Item ID: D212-664-201

Item Name: Aft Crosstube - High

DART AEROSPACE LTD		Work Order:	119105
Description: Crosstube High Aft (205/212)		Part Number:	D212-664-201
Inspection Dwg: D212-664-241 Rev: D		Page 1 of 1

DRAWING NO. D212-664-241	TITLE CROSSTUBE ASSY (205/212 HI AFT)	REV. D	DART AEROSPACE LTD ENGINEERING ORDER		D.E.O. NO. D212-664-241-D-1	SHEET NO. SHEET 1 OF 2	SCALE NTS
DRAWN	CHECKED	MFG. APPR.	APPROVED	DE APPR.			
DATE 11.04.07	DATE 11.04.11	DATE 11.04.12	DATE 11/04/12	DATE 11.04.12

D212-664-241/-241B
ASSEMBLY DETAIL

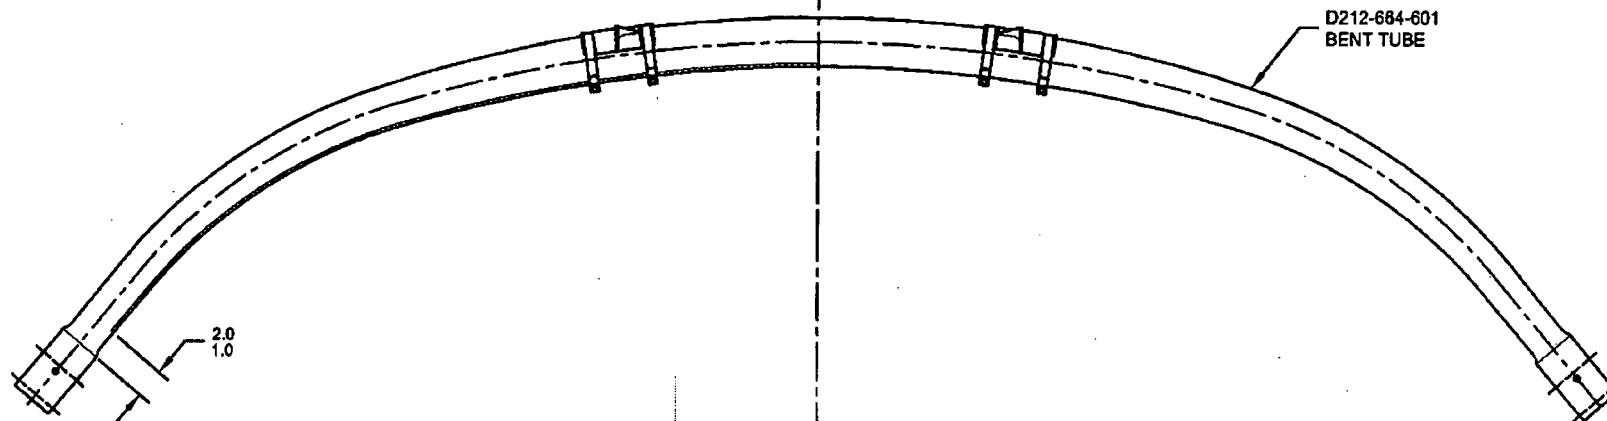
PURPOSE:

ADD AN INSPECTION WINDOW TO UNDERSIDE OF CROSSTUBE.

NOTES 2 OF SHEET 1 IS AMENDED AS FOLLOWS:

- 2) FINISH: CHEMICAL CONVERSION COAT PER DART QSI 005 4.1
PRIME INSIDE AND OUTSIDE PER DART QSI 005 4.2
MASK UNDERSIDE OF CROSSTUBE AS SHOWN (HATCHED AREA) AND
PAINT OUTSIDE PER DART QSI 005 4.2
REMOVE MASKING AND APPLY CLEAR COAT

- 2) FINISH: CHEMICAL CONVERSION COAT PER DART QSI 005 4.1
PRIME INSIDE AND OUTSIDE PER DART QSI 005 4.2
PAINT OUTSIDE PER DART QSI 005 4.2

MASK AREA PRIOR TO PAINTING,
REMOVE MASKING AFTER PAINT
AND APPLY CLEAR COAT

FIGURE 1: SUPPORT INSTALLATION

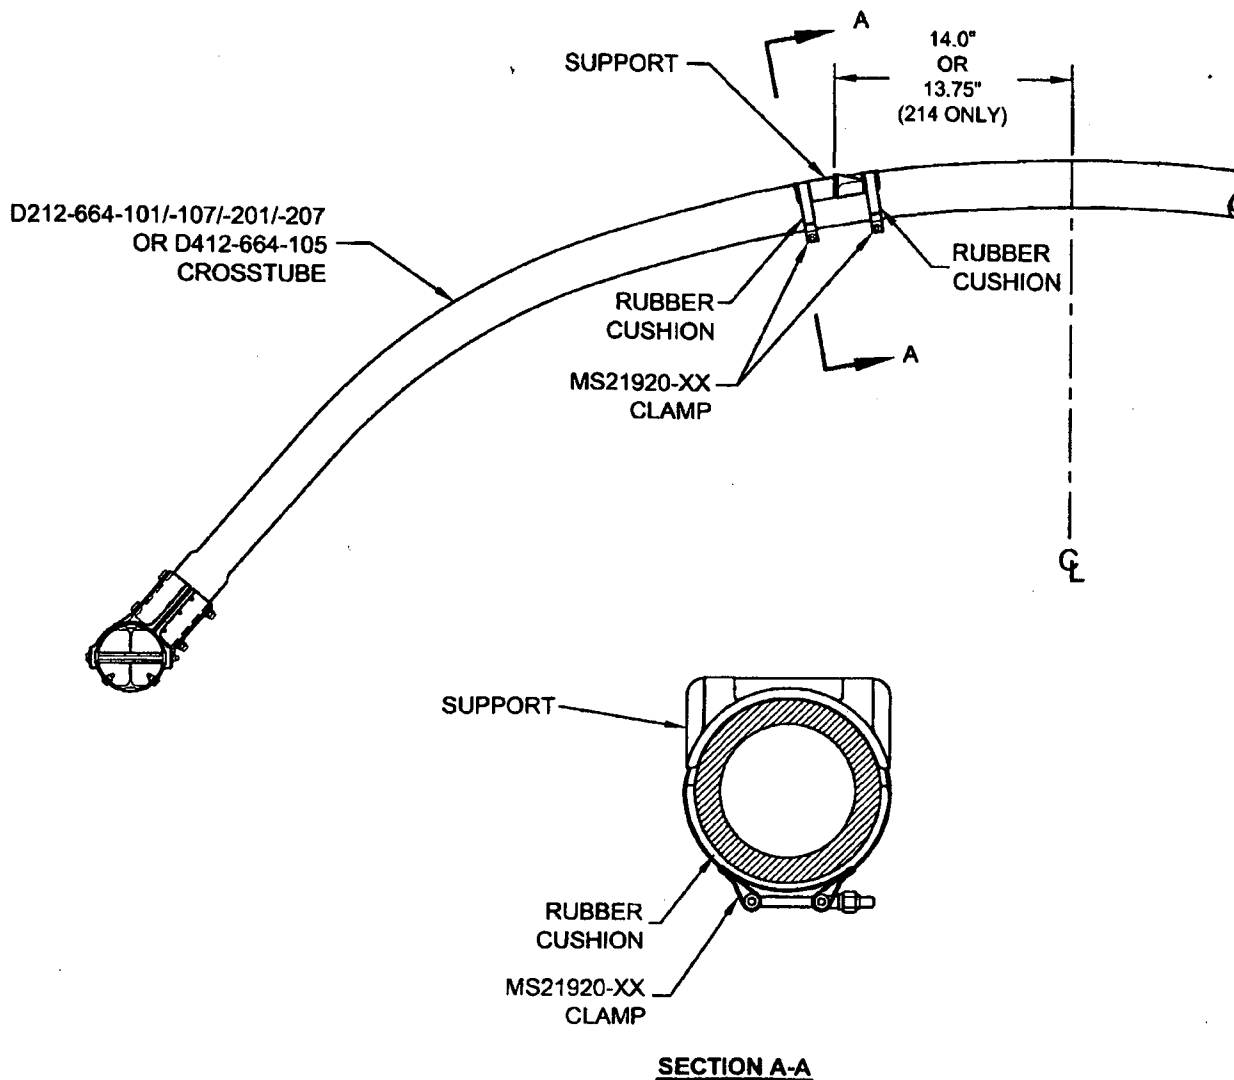
PURPOSE:

The supports on the following crosstubes are now installed using Proseal instead of Magnobond:

For the crosstubes listed above, section 32.4 of ICA-D212-664 is amended as follows. Use Figure 1 of this service instruction and Figures 32-2 to 32-9 of ICA-D212-664 for further reference. For crosstubes of an earlier change number, it is recommended that if the supports are removed, the supports should be reinstalled using the procedure listed below.

- 32.4.1 Locate the area on the crosstube for installation of support (see Figure 1 of this service instruction). For D212-664-101/-107/-201/-207 and D412-664-105 crosstubes, the outward face of the support tabs should be 14.0" (355mm) from the crosstube center for 204/205/210/412/UH-1 aircraft. For installation on 214B/B-1 aircraft, the outward face of the support tabs should be 13.75" (349mm). Ensure paint finish of crosstube is intact; touch up as required per Chapter 5 (5.3.9) of ICA-D212-664.

- 32.4.2 If present, remove any paint/primer on bottom of supports. Abrade mating surfaces of support and crosstube with 400-grit sandpaper. Saturate a clean cloth with MEK or 4105S Wash'n'Wipe Degreaser or equivalent and wipe until there is no residue.

- 32.4.3 Ensure a layer of 3M Scotch-Weld 2216 B/A Epoxy Adhesive is on the bottom of the support. If required, either apply or touch-up support to have a 0.03" to 0.05" thick layer of adhesive over the entire mating surface. Allow supports to cure for 24 hours.

- 32.4.4 Abrade mating surfaces of support (after cure) and crosstube with 180-grit sandpaper. Saturate a clean cloth with MEK or 4105S Wash'n'Wipe Degreaser or equivalent and wipe until there is no residue.

- 32.4.5 Apply a 0.04" to 0.07" thick layer of Proseal 890 Class B or AMS-S-8802 Class B sealant underneath applicable support and install support as shown in Figure 1 of this service instruction.

- 32.4.6 Install the clamps opposite to crosstube support as shown in section A-A of Figure 1. Install rubber cushions underneath each clamp around the bottom circumference of the crosstube up to the crosstube centerline. Torque clamps 80-100 in-lb (9.0-11.3 Nm). It is acceptable to use smaller or larger sized MS21920-XX clamps than those listed in ICA-D212-664, ensure that after torquing the clamps per this instruction, the nuts are in safety but not bottomed out

CRUSHING OF D212-664-201

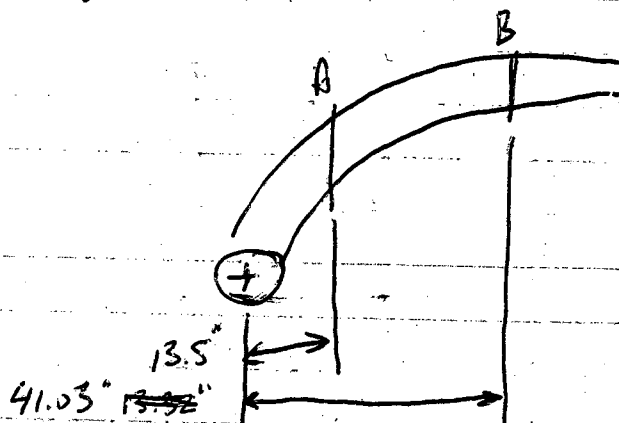
Acceptability of 8% CRUSHING

Point A: $OD1 = 2.548 \text{ in}$ $OD2 = 2.992 \text{ in}$
 $CRUSHING = (2.992 - 2.548) / (2.992 + 2.548) = 8\%$
 $I = 1.476 \text{ in}^4$
